Department of Transportation

MEMORANDUM

SUBJECT: BZA Case No. 20075 – 1050 31st Street NW (Rosewood Hotel)

Figure 1. Inventory of Curbside Management and On-Street Parking (Source: Gorove/Slade, CTR, Figure 8, 6/10/2019)

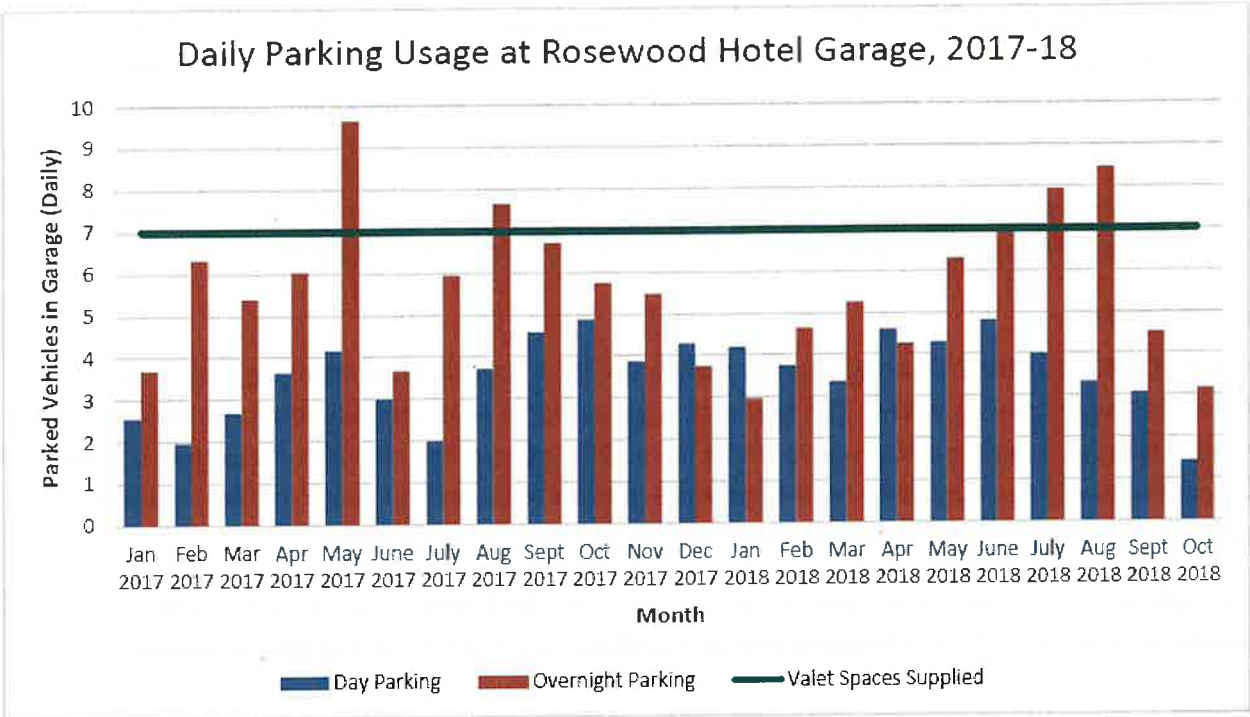
The Applicant is required to provide and is seeking relief from all 20 vehicle parking spaces. In situations where an Applicant is requesting relief from five (5) or more vehicle parking spaces, DDOT requires an on-street parking occupancy study to understand the action's impact on neighborhood parking conditions. The study area is shown in Figure 1. On-street parking near the site is composed of metered spaces, Residential Permit Parking (RPP) spaces, and time-restricted spaces.

DDOT finds the amount of available on-street and garage parking within a two block radius sufficient to meet the needs of the project in conjunction with the above referenced TDM plan.

Figure 2. Daily Parking Usage, January 2017-October 2018 (Source: Gorove/Slade, CTR, Figure 6, 6/10/2019)

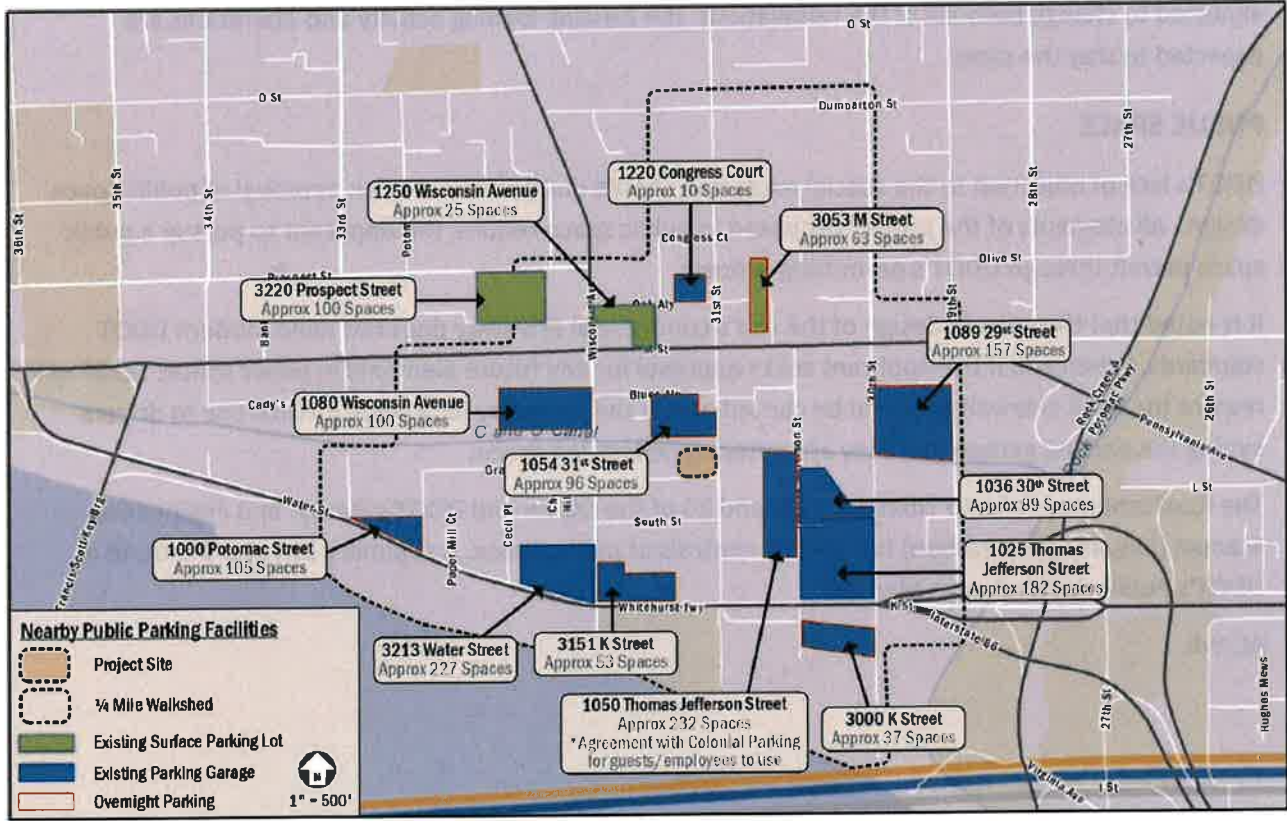
The Applicant also studied the historic parking demand of the site to determine the average capacity of the parking garage. Figure 2 presents the average daily parking usage from January 2017 to October 2018, consisting of both daytime parking and overnight parking. As seen in the figure, the daily averages rarely exceeded seven (7) spaces, with no month averaging more than 10 daily parked vehicles.
